This meeting of the Grimes Planning and Zoning Commission was called to order Tuesday December 3, 2019 at 5:30 P.M. at Grimes City Hall.

The Development Services Department is in receipt of a proposed Site Plan for Project Viking. Based on the review of the provided submittal materials, staff have the following comments:

SITE PLAN FOR: PROJECT VIKING

The Development Services Department is in receipt of a proposed Site Plan for Destination Market Plat 3. Based on the review of the provided submittal materials, staff have the following comments:

DESTINATION MARKET BLDG 2
NORTH EAST TELKAY LANE
GRIMES, IA
11.25.2019

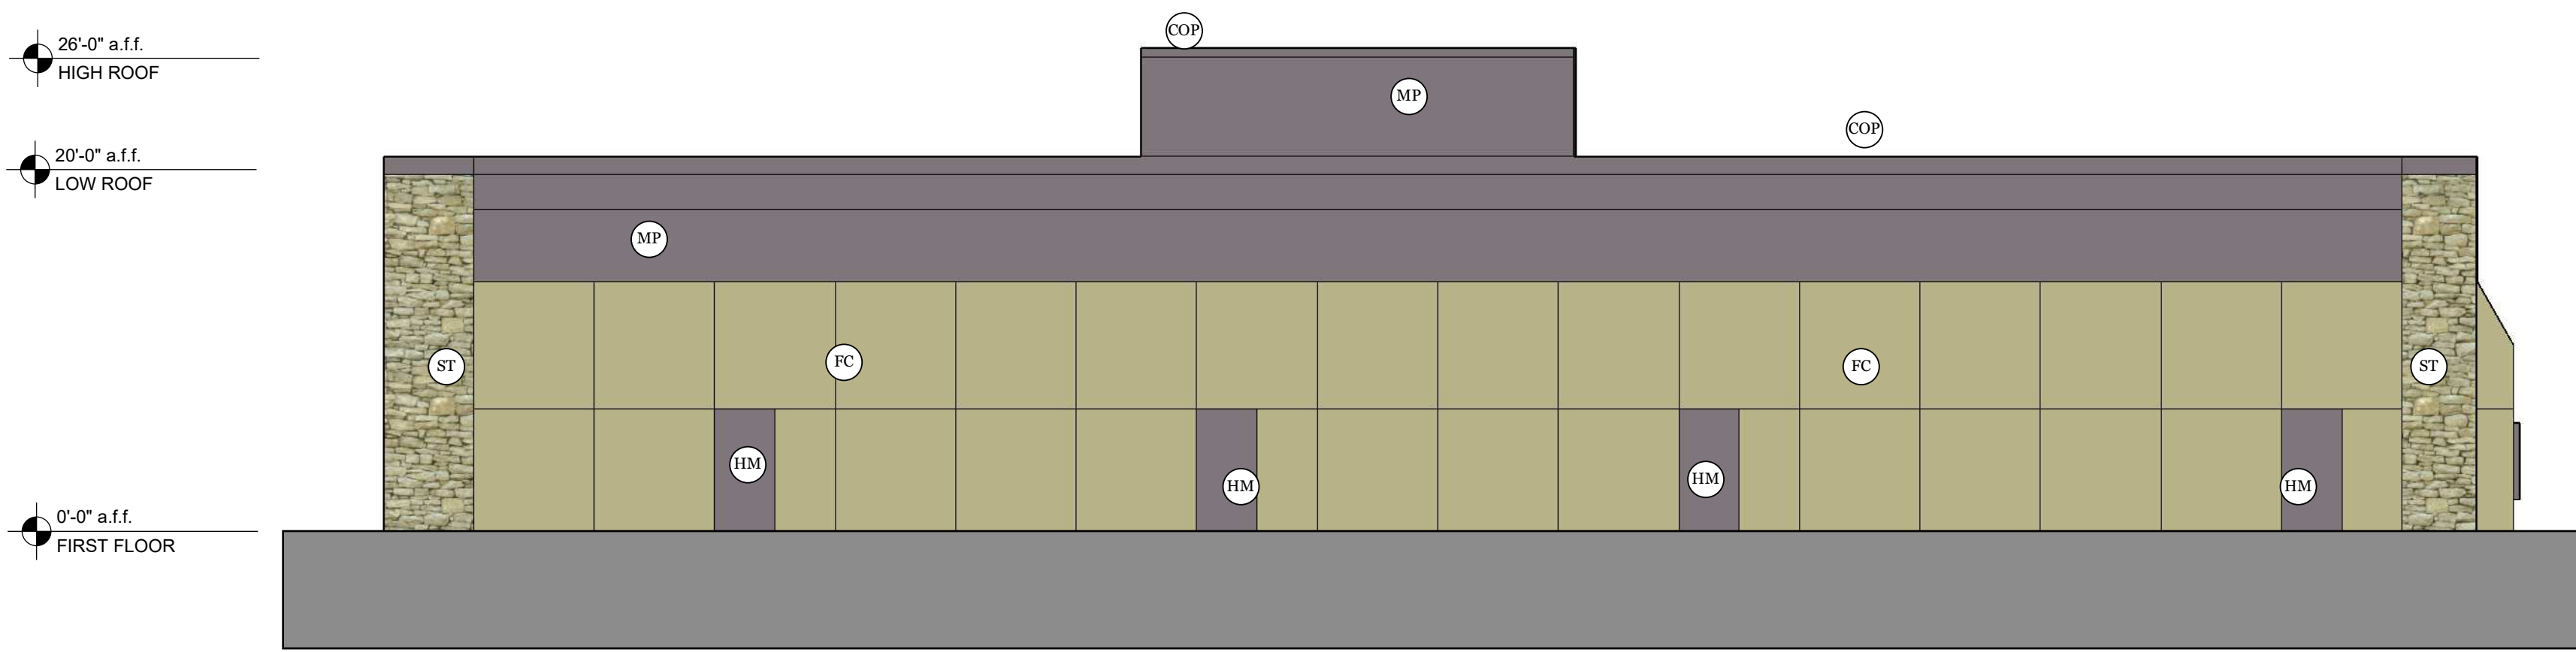
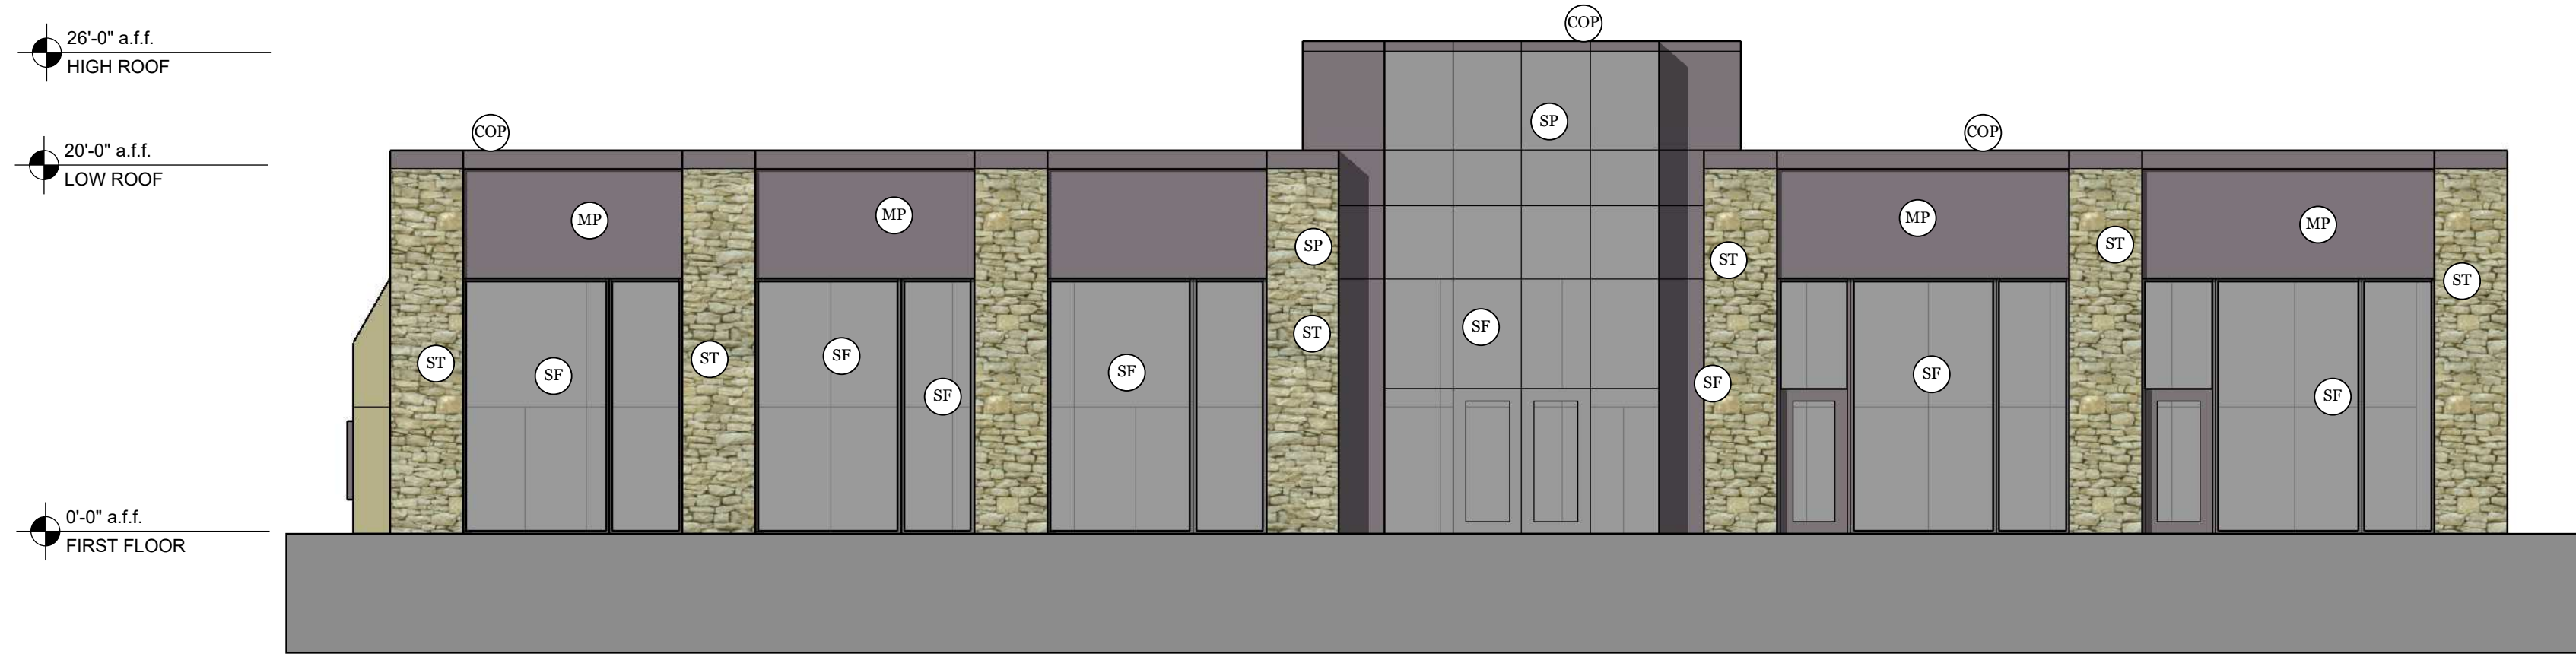
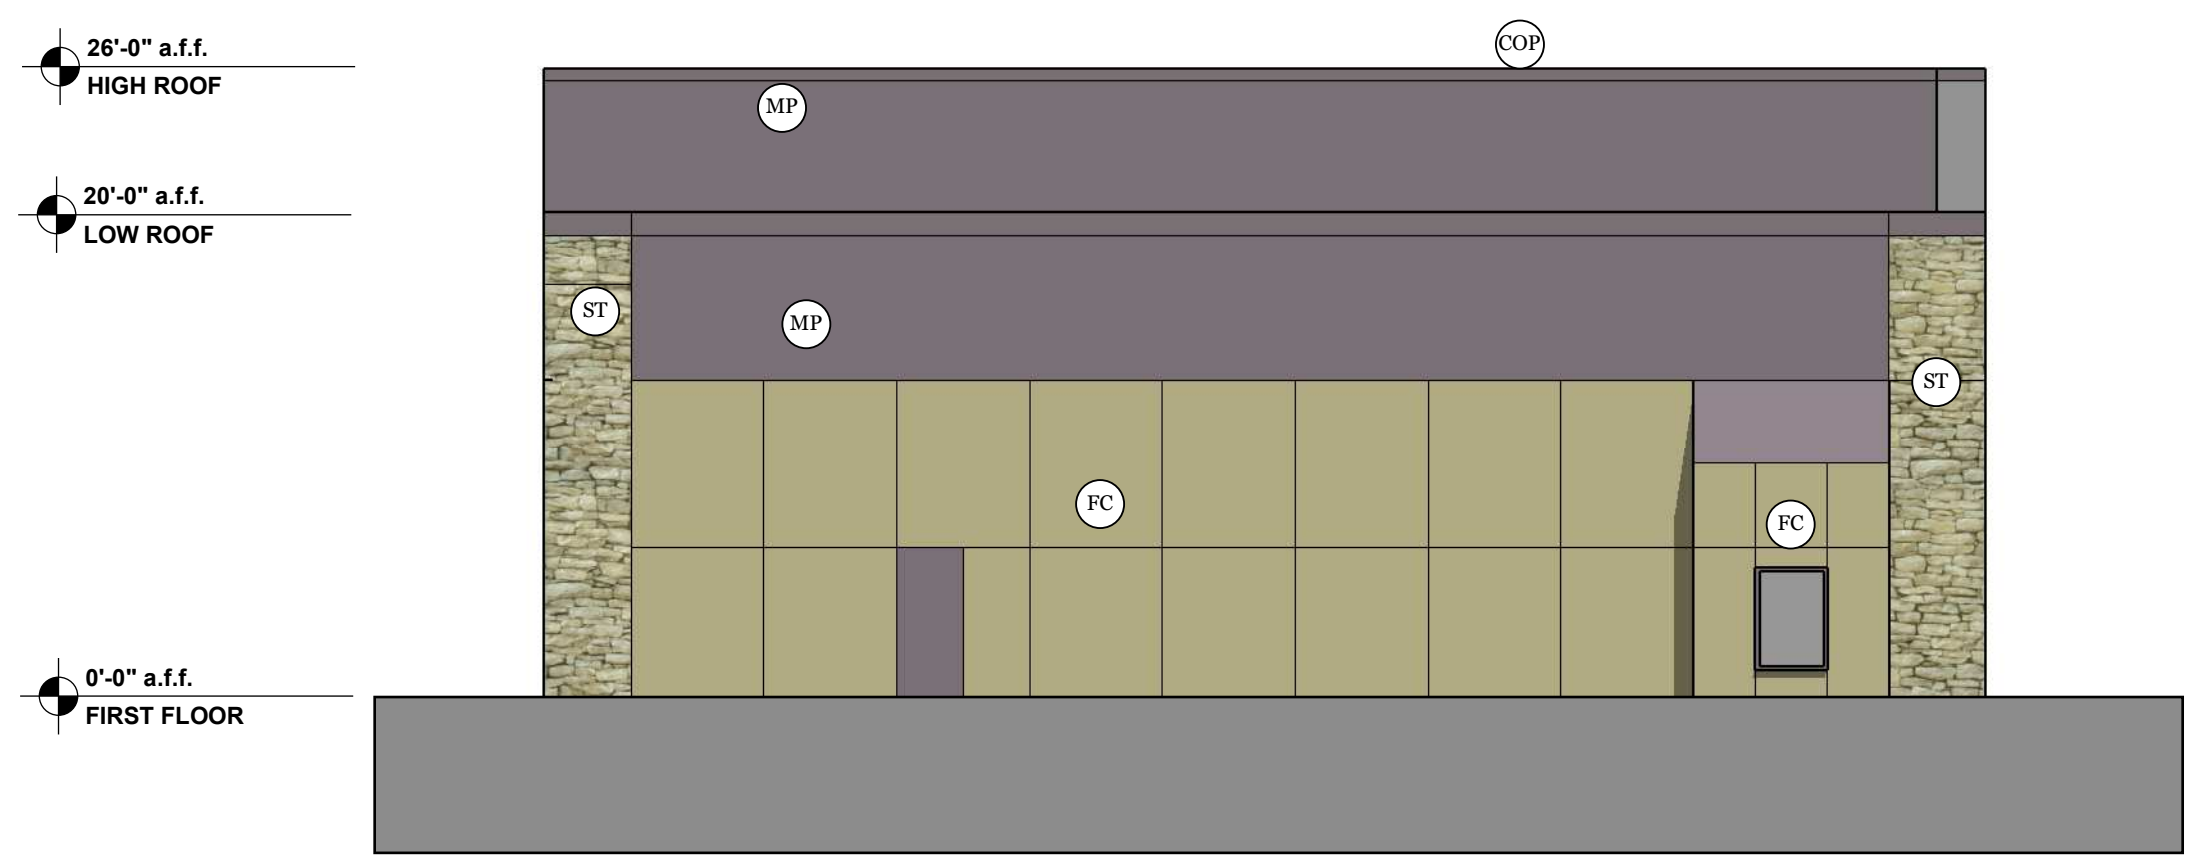
- 51. Please provide material percentages on all 4 sides of the building. **No revisions made.**
- 52. Staff would like to see additional architectural elements provided on the north elevation. **No revisions made.**
- 53. Note that due to the proposed materials not being 100% masonry, the City Council will need to pass the approval at 4/5. **No revisions made.**
- 54. Staff questions the placement of the drive-through window, and it makes practical sense. **No revisions made.**

55. As similar to the east elevation, please provide additional glazing on the west side to balance the building. **No revisions made.**

56. Please provide the roof deck height as it relates to the parapet elevation. Note that all roof top mechanical units will need to be screened. **No revisions made.**

UTILITY NOTES

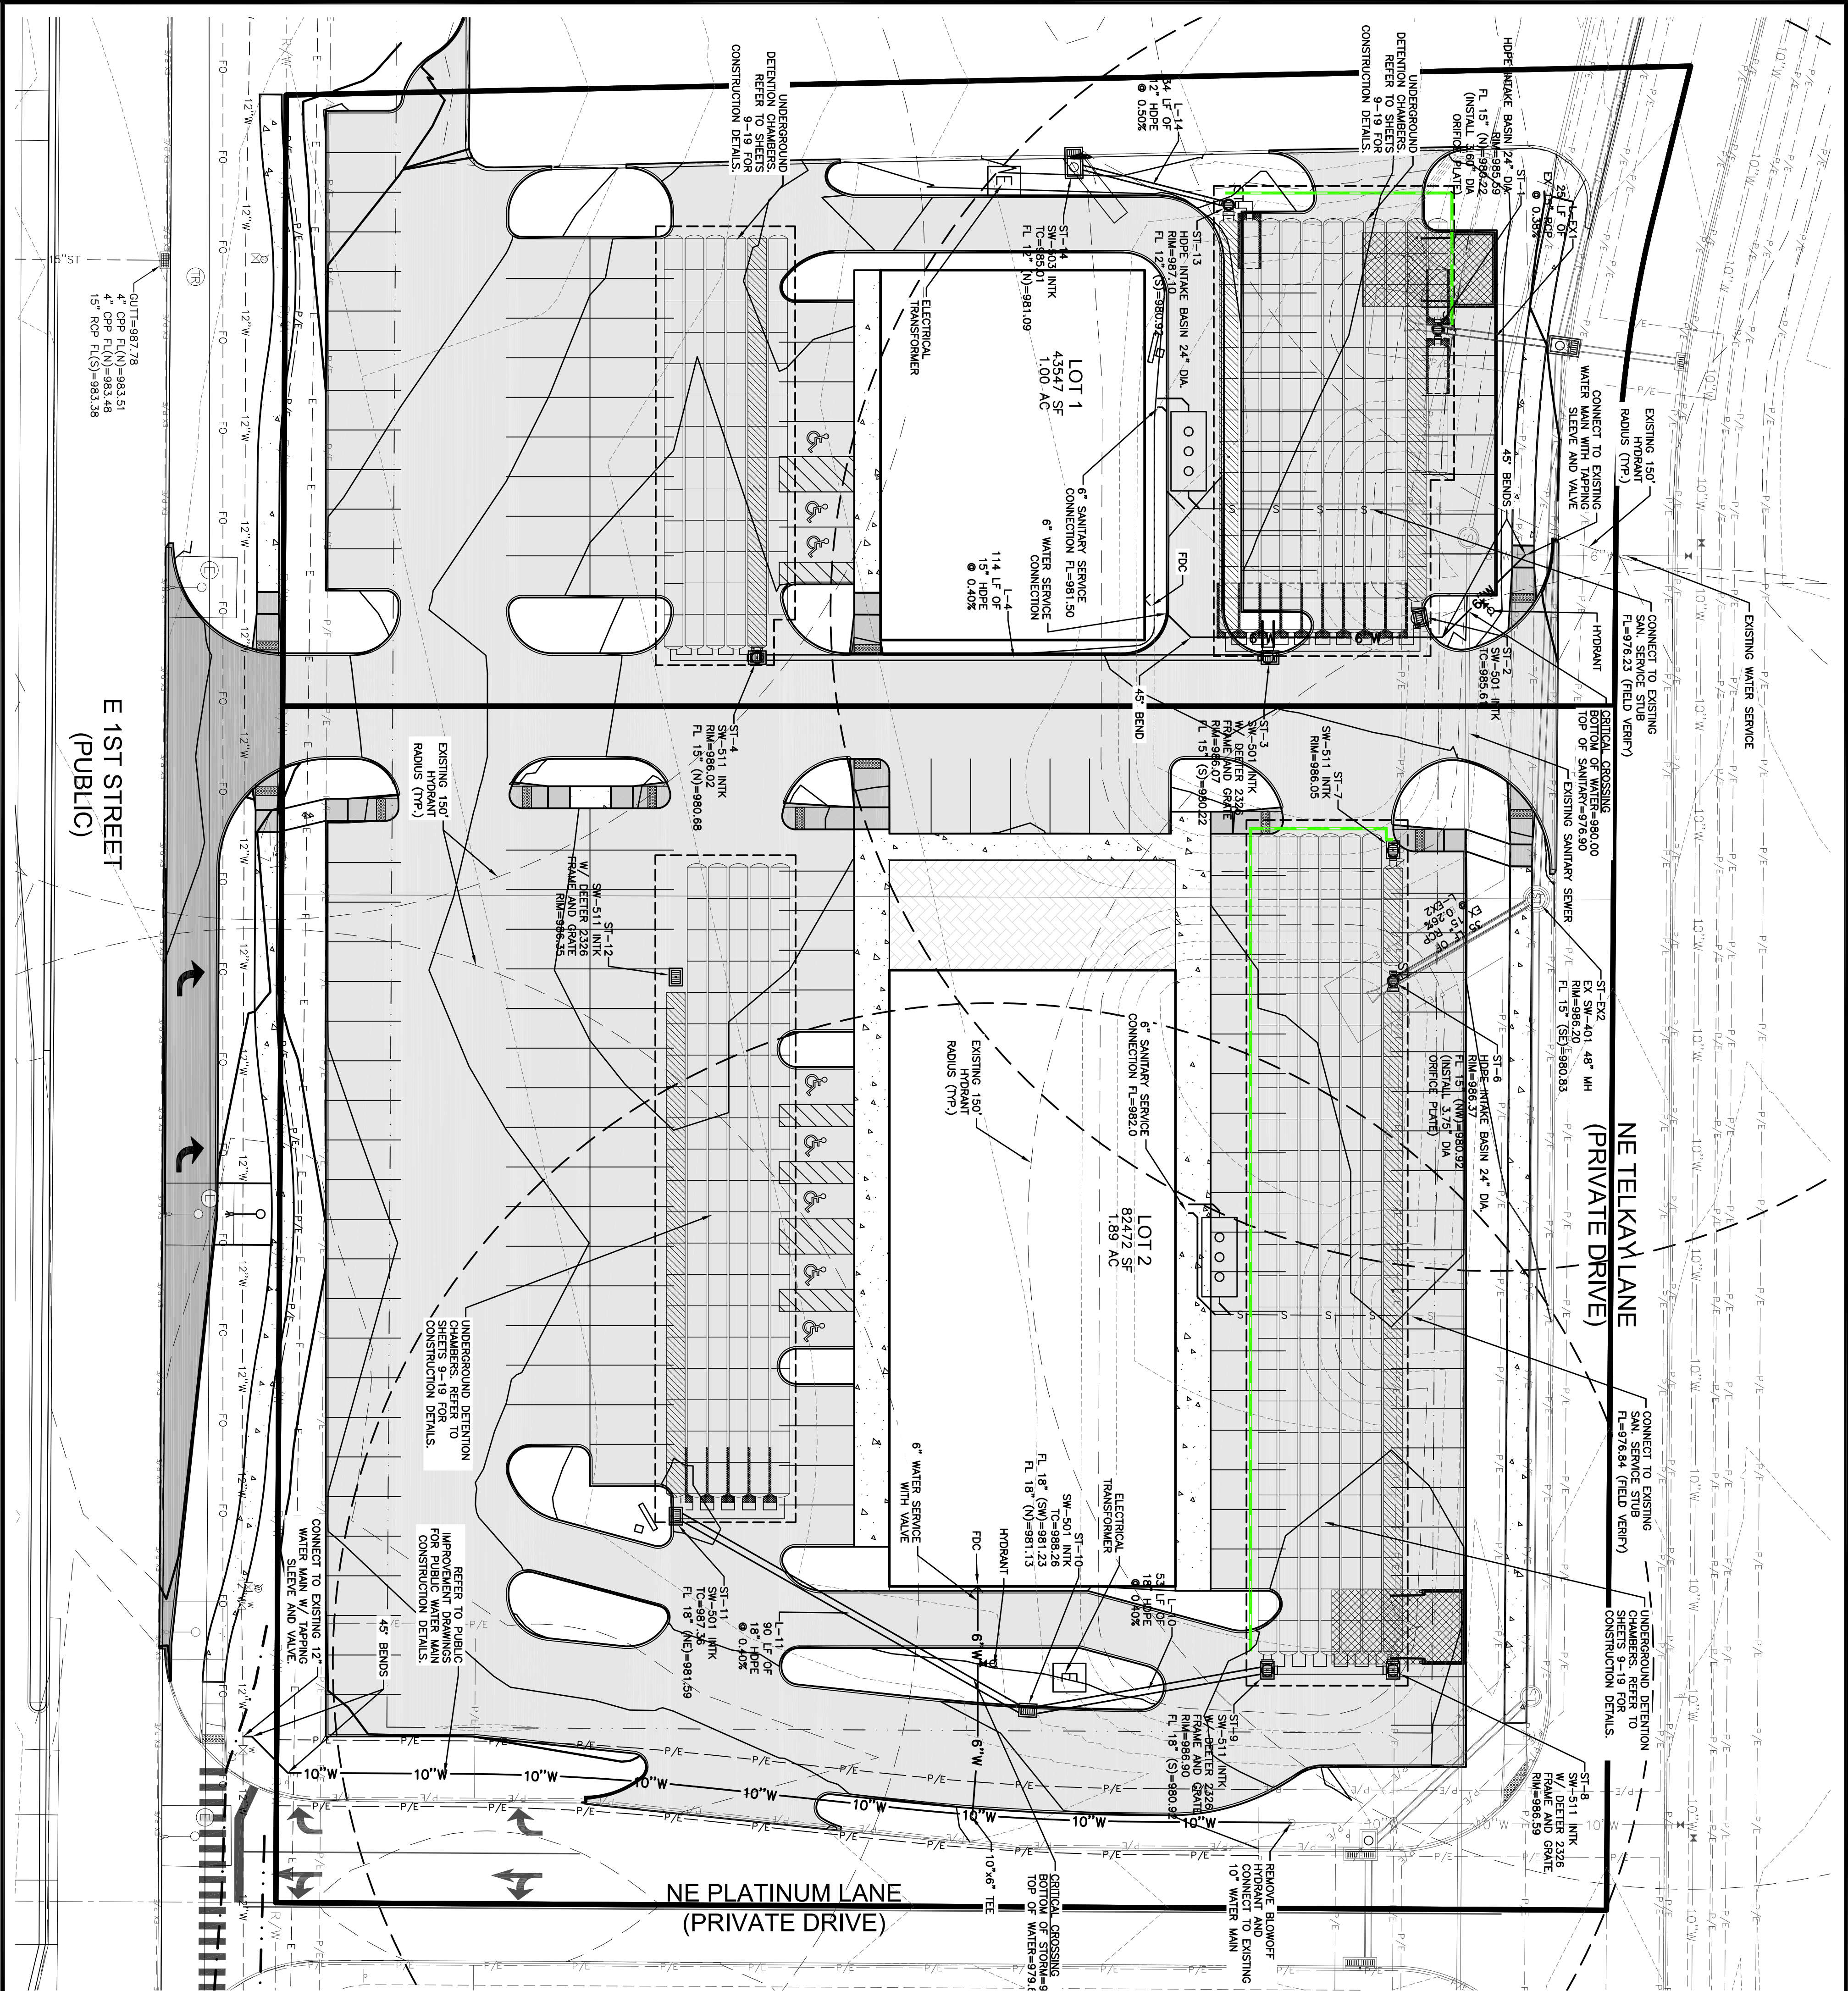
- ~~32. Note that construction drawings for the public water main will be required.~~
33. It appears that there are no fire hydrants on site. Please provide in a manner that allows all areas of the building to be accessed along a 150-foot route path from the site hydrants. **As shown, the minimum requires are not being met. Hydrant coverage must be along an approved route (150-foot). This means that all sides of the building must be covered along the 150-foot route.**

34. Note that it appears based upon the square footage, that both buildings will need to provide a fire suppression system. Please provide a detail for the fire/domestic connection, and note the location of the FDC. **FDC must have a clear path of access. Both FDC's have the potential to be blocked by parked cars of queue space Please revise.**

39. Staff questions if the existing water services will be abandoned. **Note that the service will need to be repaired at the main.**
